SERVICE BULLETIN

M-1241A

2009 FLHTCUTG TRUNK DOOR SEAL PRODUCT PROGRAM 0907

Purpose of Revision

Figure 1. Trunk Door Seal

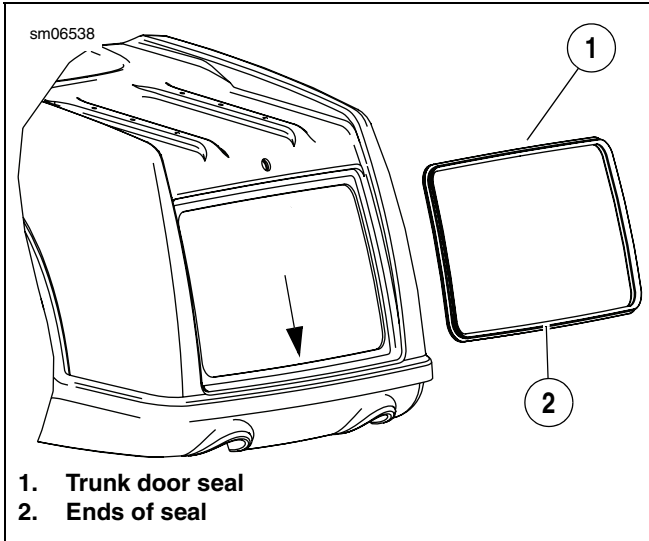
5. Peel back 3-4 in. (76-102 mm) inches of backing material.
6. See Figure 1. Beginning at the bottom-center of the opening, adhere the seal even with the edge of the opening as shown in Figure 2. Work only 3-4 in. (76-102 mm) at a time.

Figure 2. Cross Section of Gasket Placement

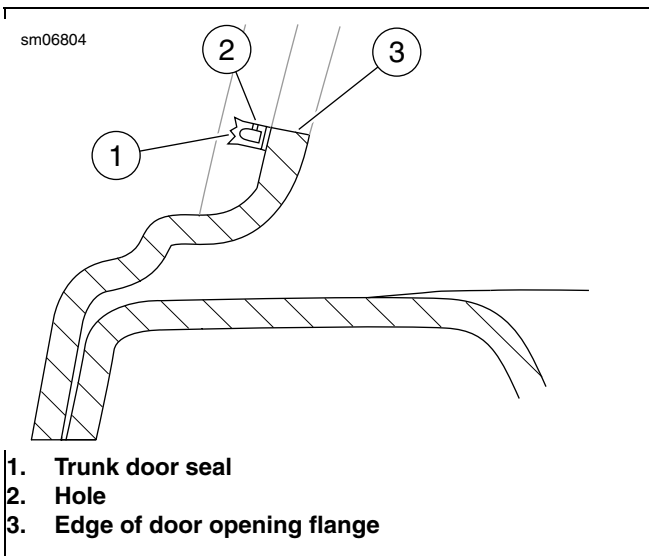
See Figure 2. Install the **new** seal (1) with the holes (2) toward the inside of the opening (3).

Figure 5. Install O-Ring

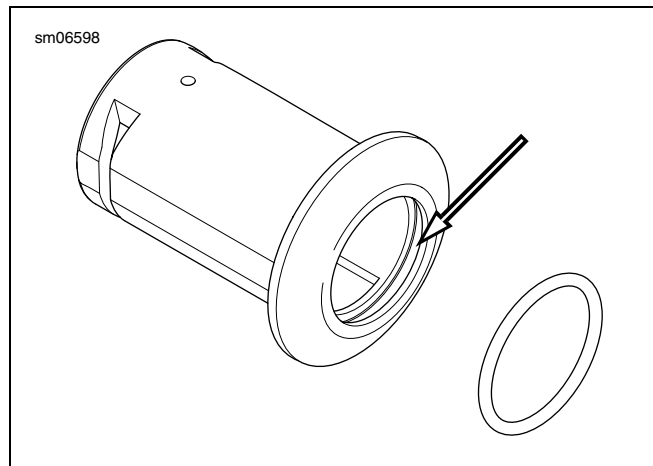
- See Figure 5. Install the O-ring in the groove in the **new** bezel and apply a light film of H-D Contact Lubricant (Part No. 99861-02). Install original lock assembly in **new** bezel.
- See Figure 3. Install lock assembly using original foam washer (2) and secure with supplied U-clip (1). Verify latch operation.
